Auditcon®

PRODUCT BULLETIN

Product:	Auditcon® 2 Series - Vertical Deadbolt
Subject:	Change in Installation Instructions
Bulletin:	A073121
Date:	September 1, 2022

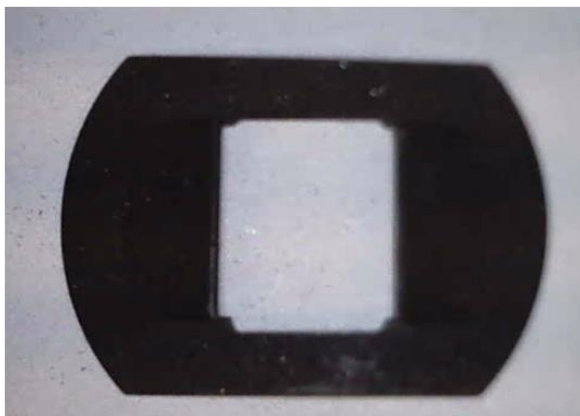
- Models** **52, T52, 252, 552 Vertical Deadbolt**
- Component Change- Retainer Clip 306111
- Impact** **Change in Spindle Length Requirement for Installation**
- Change in Installation Instructions**

dormakaba is pleased to share this technical update with our valued customers and service partners. Effective immediately a revision to installation hardware component 306111 (Retainer Clip , Push on-.186, Heat Treat, RoHS). A new version of this clip will be included in all Auditcon vertical deadbolt models. This change will impact the installation instructions for these locks. The new version of this retainer clip has been released to replace an end of life component.

Previous Revisions of this clip required 1 1/4" (31.8mm) from the outside of the container. This change in installation procedure is documented in the installation instructions (3045.025) .

When installing a lock with the new retainer clip, mark and cut the spindle to allow 1 3/8" (34.9mm) from the outside of the container door. (plus or minus 1/8" or 3.2mm)
